Customer : CU-DAR001. Dart Helicopters Services Drawing Name : 350/355 AS X-TUBE AFT
 Job Number : 27830
 Estimate Number : 12486
 P.O. Number : N/A Part Number : D350748201
 This Issue : 7/5/2006 S.O. No. : N/A Drawing Number : IIN D350-748 P5 PREL 06.07.05
 Prsht Rev. : NC Project Number : N/A
 First Issue : N/A Type : LANDING GEAR Drawing Revision : PREL
 Previous Run : 27829 Material : N/A
 Written By : Due Date : 7/30/2006 Qty: 1 Um: Each
 Checked & Approved By : 06.07.05
 Comment : Est Rev:A New Issue 06-07-05 JLM

Customer : CU-DAR001 Dart Helicopters Services Drawing Name : X-TUBE AS 350/355 HI AFT
 Job Number : 27830A
 Estimate Number : 12483
 P.O. Number : N/A Part Number : D350748241
 This Issue : 7/5/2006 S.O. No. : N/A Drawing Number : D350-748-241 PREL
 Prsht Rev. : NC Project Number : N/A
 First Issue : N/A Type : LANDING GEAR Drawing Revision : PREL
 Previous Run : 27829A Material : N/A
 Due Date : 7/30/2006 Qty: 1 Um: Each
 Written By :
 Checked & Approved By : *JA 06 07.05*
 Comment : Est Rev:A New Issue 06-07-05 JLM

DESIGN <i>99</i>	DRAWN BY	DART AEROSPACE LTD HAWKESBURY, ONTARIO, CANADA	
CHECKED	APPROVED	DRAWING NO. D350-748-241	REV. B SHEET 1 OF 3
DATE 06.06.3

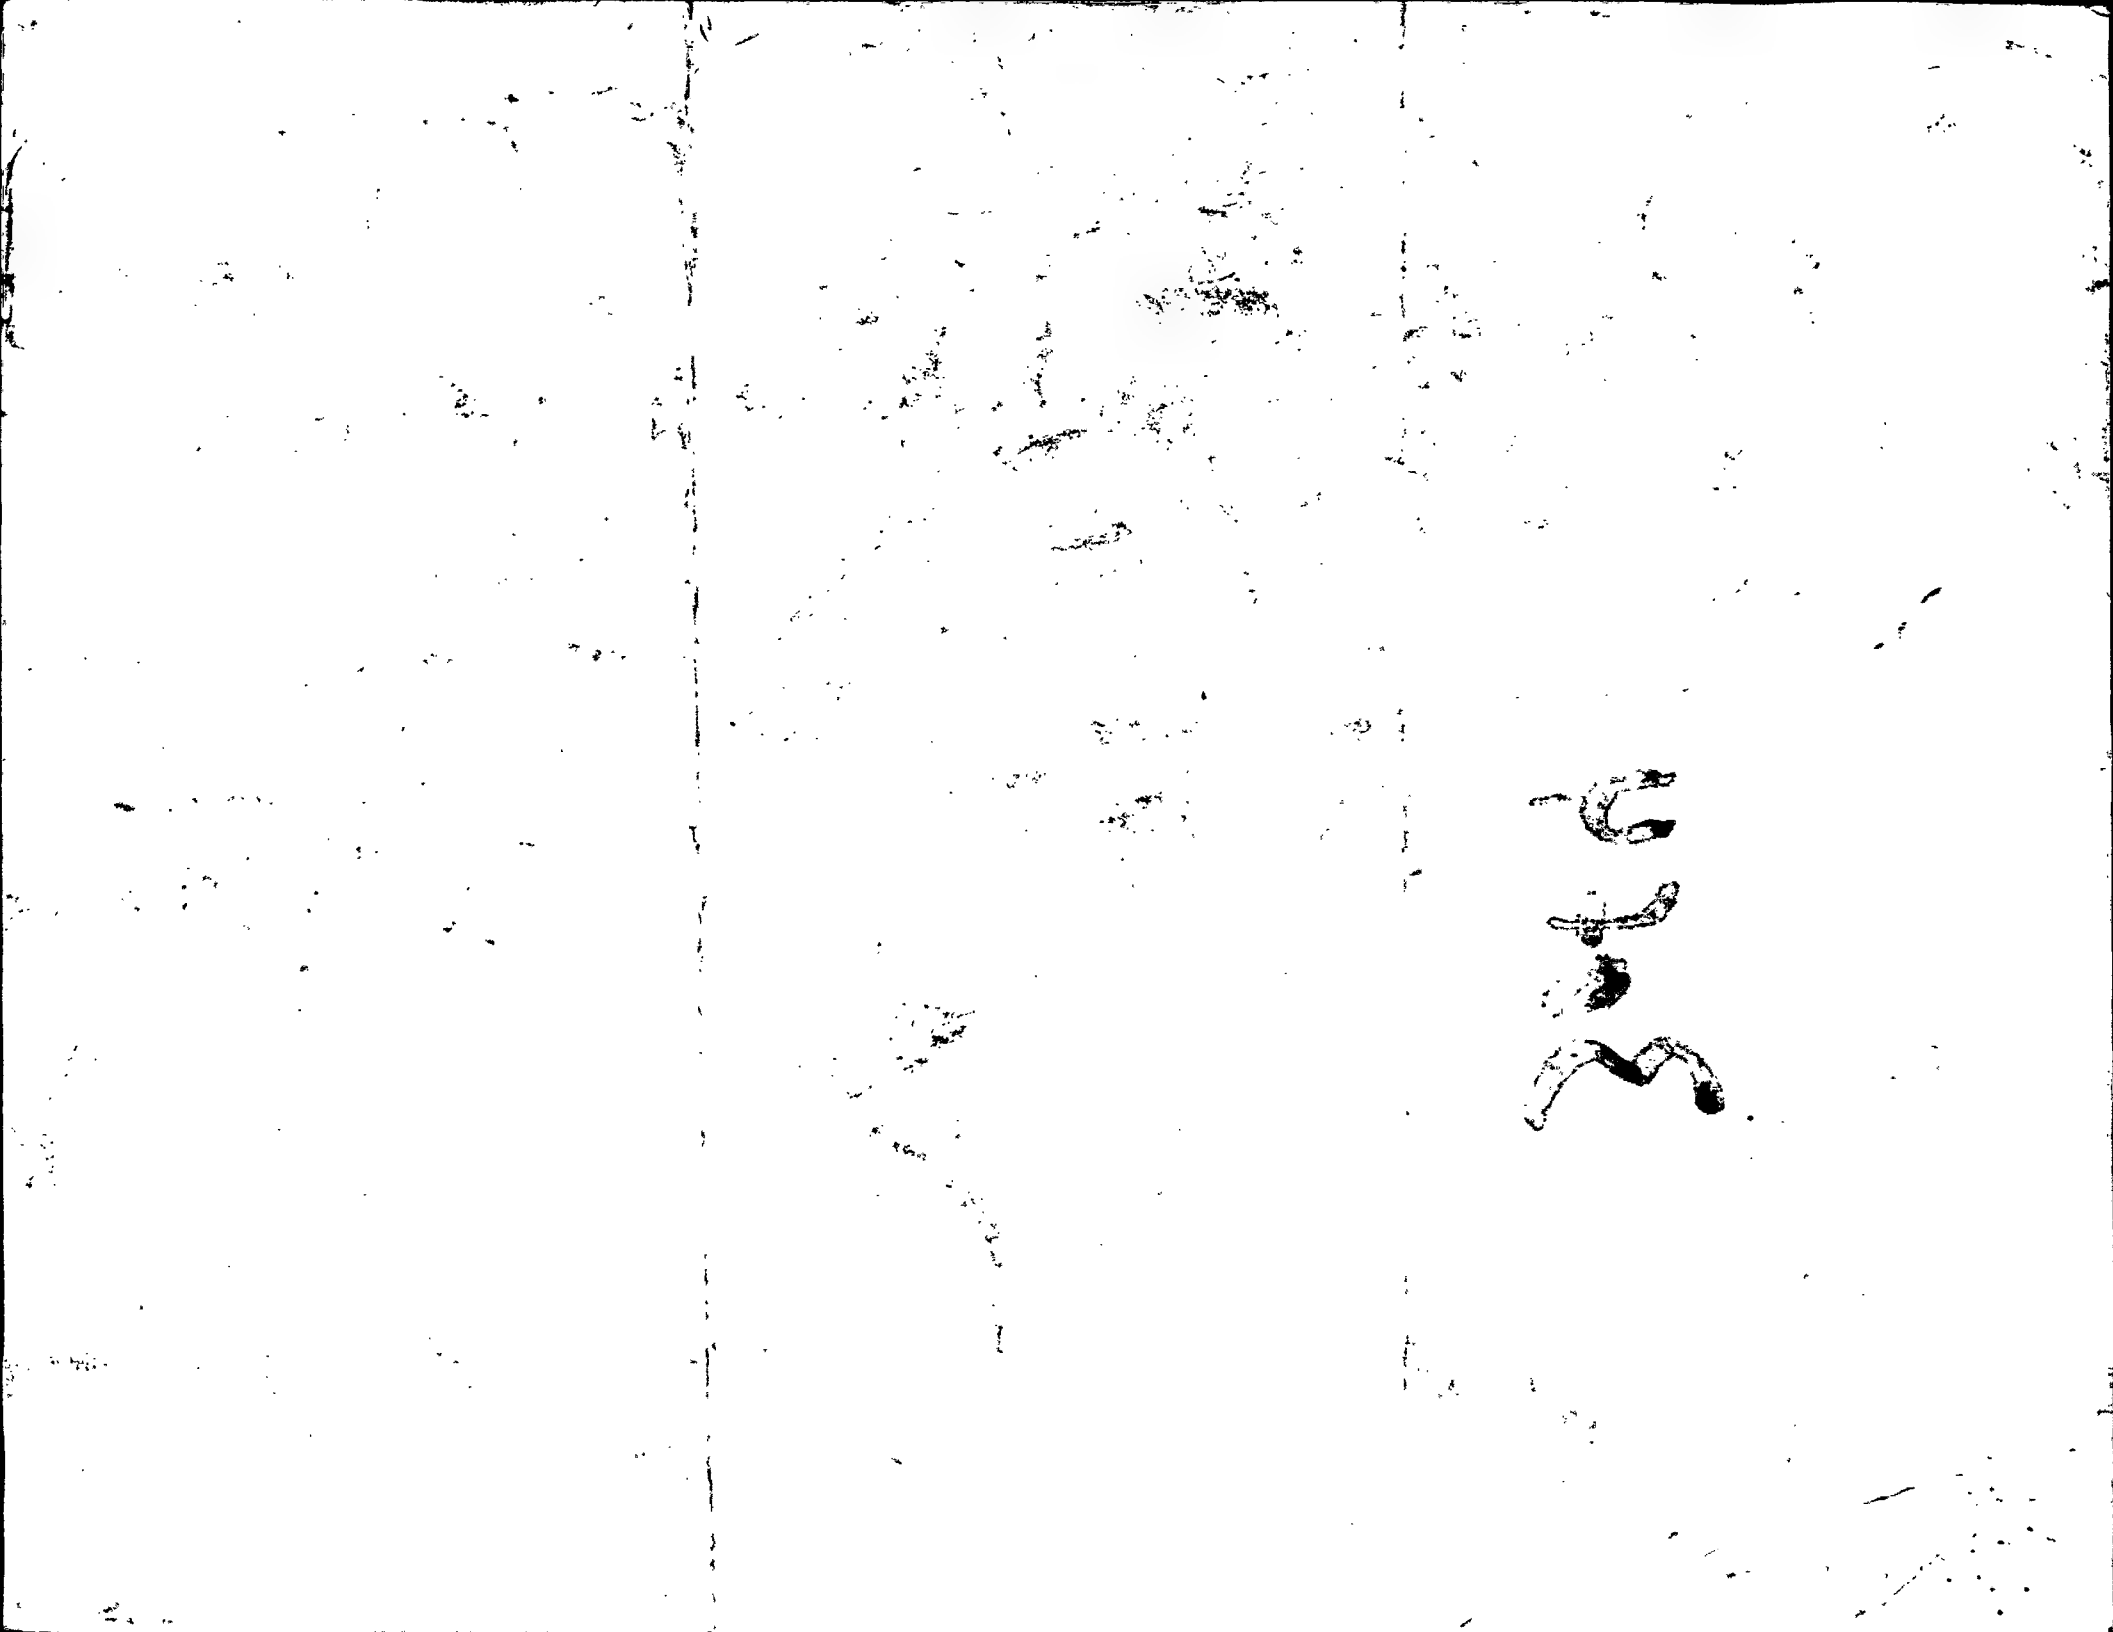
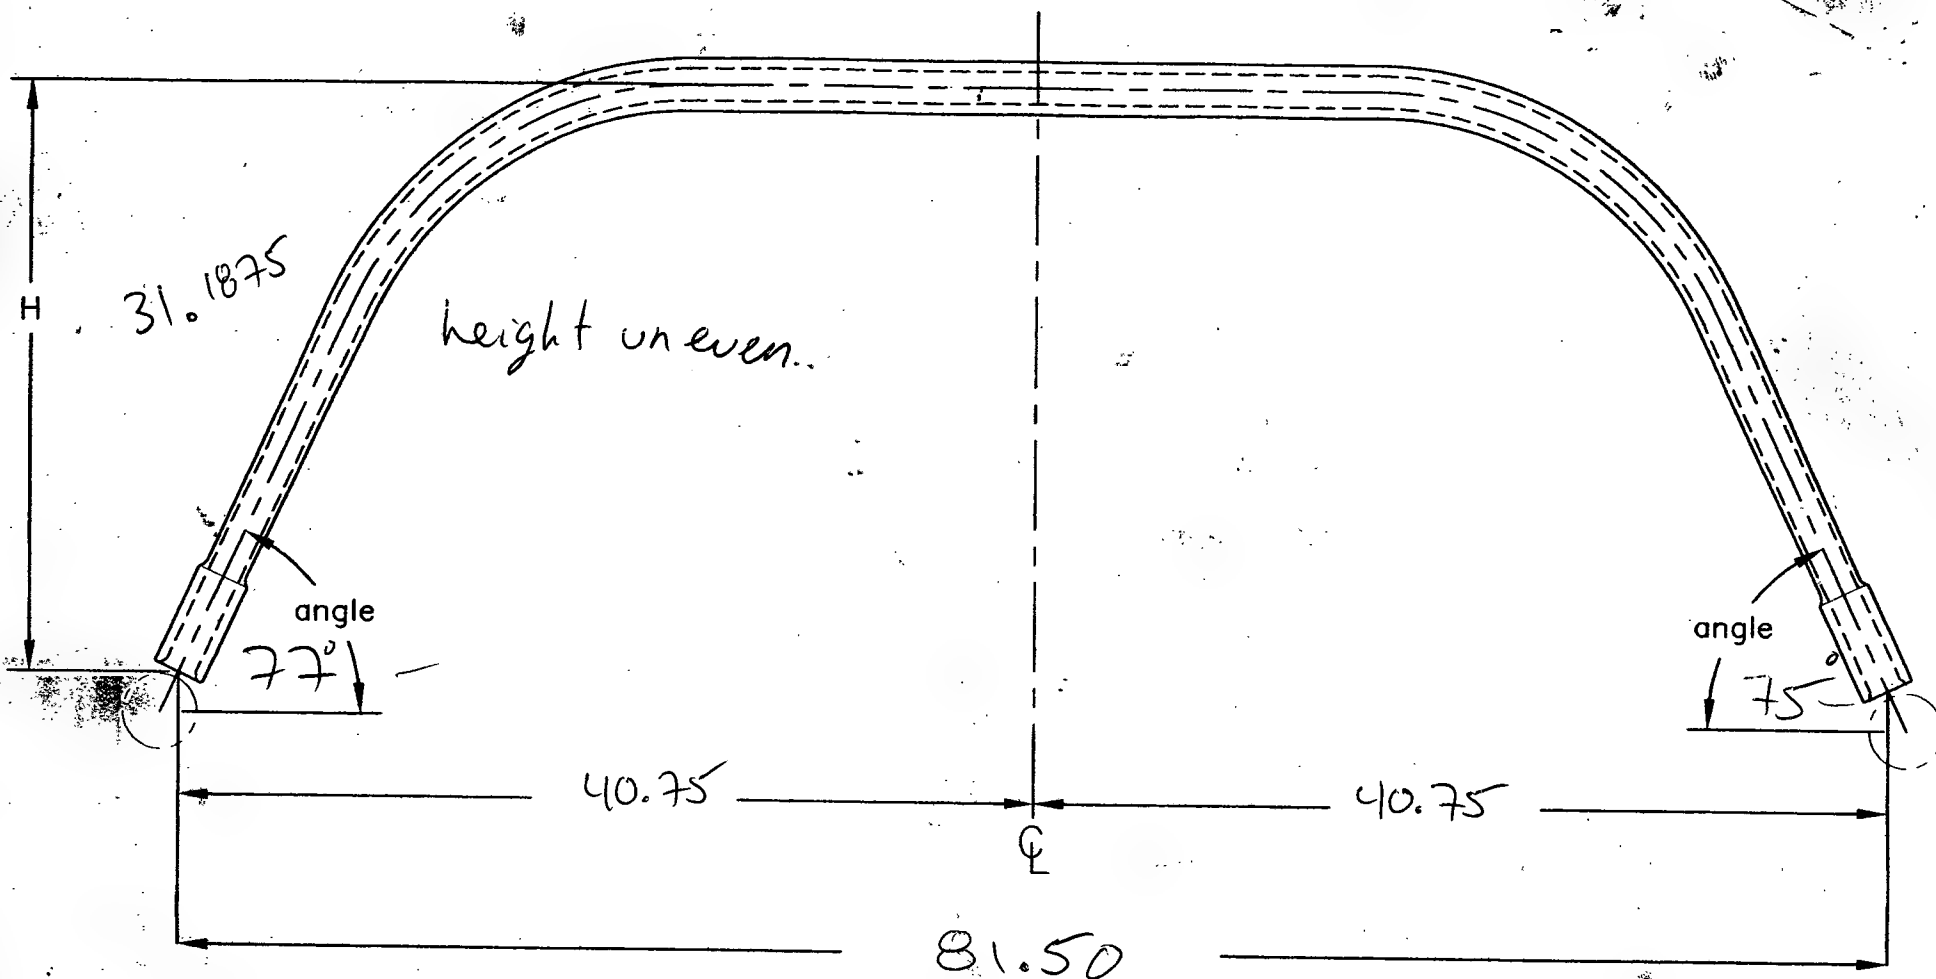
Please see attached FAI sheets for the 350 X-tubes that Dan put it together. As Dan is explaining below the last two columns named Actual Dims and variance are measurements after heat treatments.

From: Dan Stow [mailto:dstow@dartaero.com]
Sent: August 5, 2006 11:24 AM
To: sshahbazian@dartaero.com; Bill Beckett (E-mail)
Cc: chrisp@dartaero.com
Subject: 350 aft Xtube OD variations

Attached is a photo containing the FAI sheets for the 350 aft Xtubes Batches: 27827A, 27828A, 27829A, and 27830A. In the last two columns renamed Actual Dims and Variance from DWG Dims are the measurements that I took after they came back from heat treating and sand blasting. Please Note that the dimensions are not the same all the way around the OD of the tube, the majority of the circumferences of the tubes are within tolerance but there seems to be a "flat" spot in some places. Are the tubes acceptable?

D350-748-241 B27827A, B27828A, and B27830A are acceptable to me.

D350-748-241 B27829A is unacceptable to me at this point.

If you want to try to salvage it, I think we should look at the ID and calculate some inertias for comparison.

DESIGN QP	DRAWN BY QP	DART AEROSPACE LTD HAWKESBURY, ONTARIO, CANADA	
CHECKED #	APPROVED #	DRAWING NO. D350-748-241	REV. C SHEET 1 OF 3
DATE 06.08.14		TITLE CROSSTUBE (AS 350/355 HI AFT)	SCALE NTS
A	06.03.31	NEW ISSUE	
B	06.06.30	ADD D6018-125 & PRIME AND PAINT	
C	06.08.14	ADD CAD PLATING

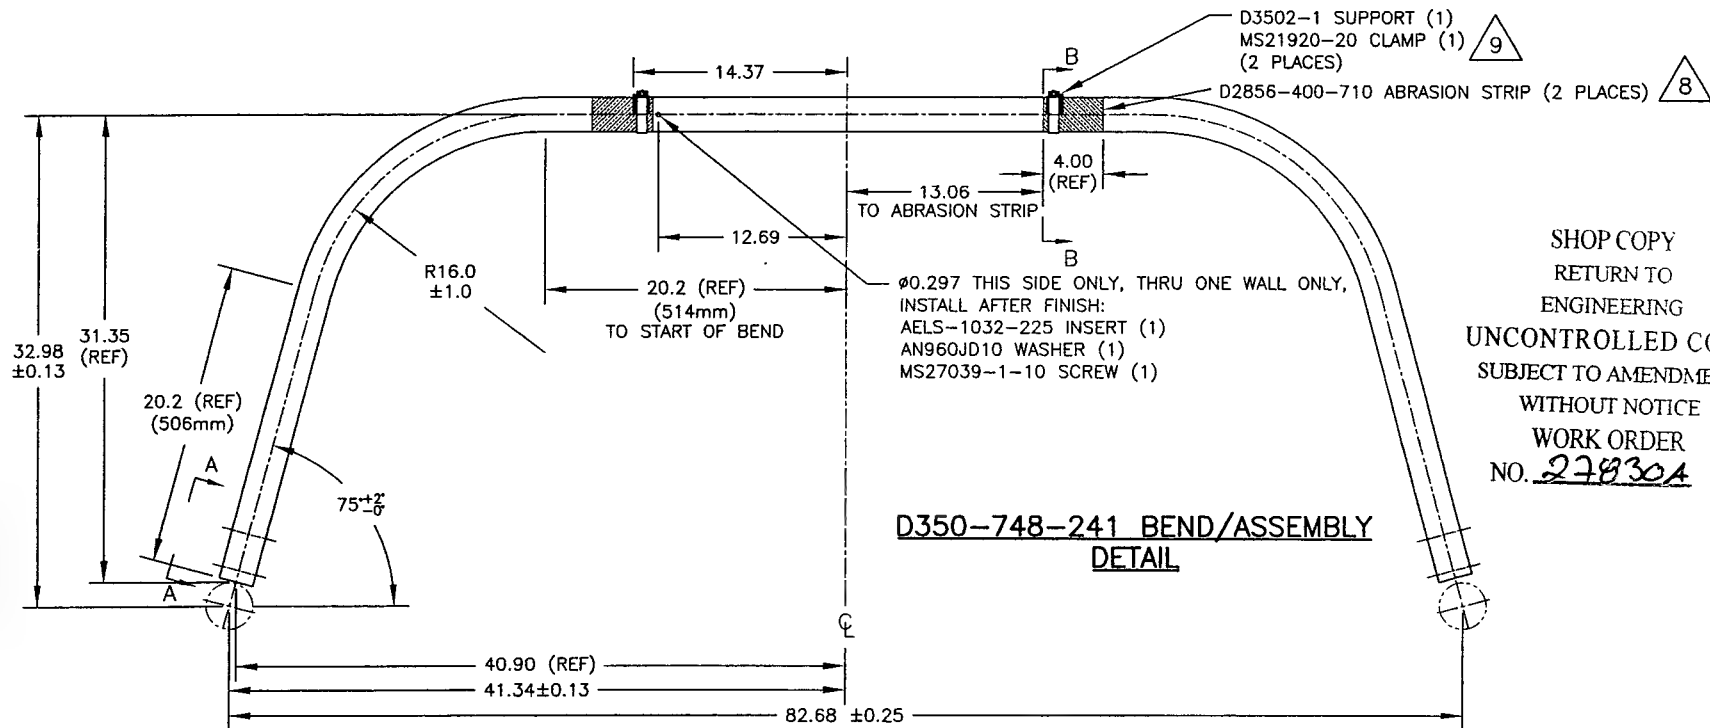
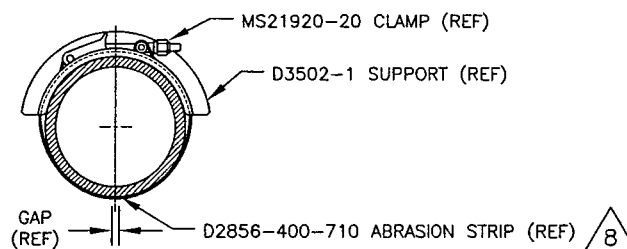
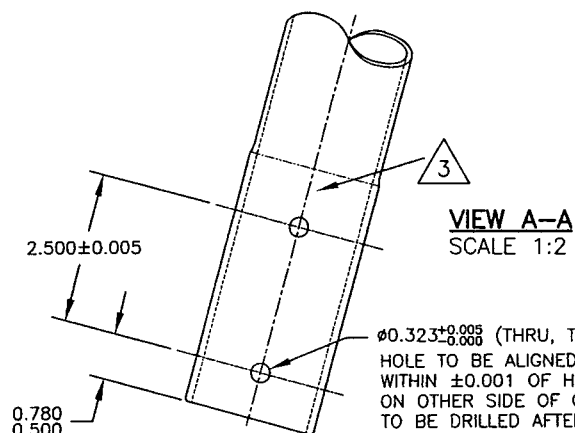
From: David Shepherd [dshepherd@dartaero.com]
Sent: October 3, 2006 10:03 AM
To: 'Chris Provencal'
Cc: 'S Shahbazian'; 'Beckett, Bill'
Subject: RE: 350 xtube cad plating

As we discussed, I had some concern about the stress relieving comment on the packing slip because I didn't realize that by heating up the tubes, we would be stress relieving them. We didn't test our crosstubes in a stress relieved condition. The crosstubes we tested had compressive stresses in the tensile stress areas of the crosstube. However, because the highest stress areas are in the unbent portion of the crosstube and because I think we had so much margin in our drop test (no shock absorbers, damaged parts, overloaded, etc ...), my gut tells me that we are OK and I don't think we need to re-test.

I'm glad to hear that we are dimensionally checking the crosstubes after all the heating. I think this step should be added to the work order on receiving inspection for every crosstube.

As we discussed, I think a drawing revision is in order. I think reference to a QSI for the procedure outlined on the packing slip would be best.

From: Chris Provencal [mailto:cprovencal@dartaero.com]
Sent: Monday, October 02, 2006 2:17 PM
To: David Shepherd (David Shepherd)
Cc: 'S Shahbazian'; 'Bill Beckett (Bill Beckett)'
Subject: 350 xtube cad plating

-I originally told you that the magnetic particle was done first. That was the plan, but they ended up following the drawing (cad->magnetic). The invoice I sent you gives the correct order the work was done.

-The cad plating was done to AMS-QQ-P-416B (issued 2004 by SAE) instead of the drawing's' QQ-P-416F (issued 1991 by military). I don't see a problem with this since it's a more current issue, and the only reason we specified QQ-P-416F is because that's what the "old" never-used supplier suggested.

-The dims were re-checked after cad plating and the dimensions did not change.

I think the modified CAD plating procedure is acceptable.
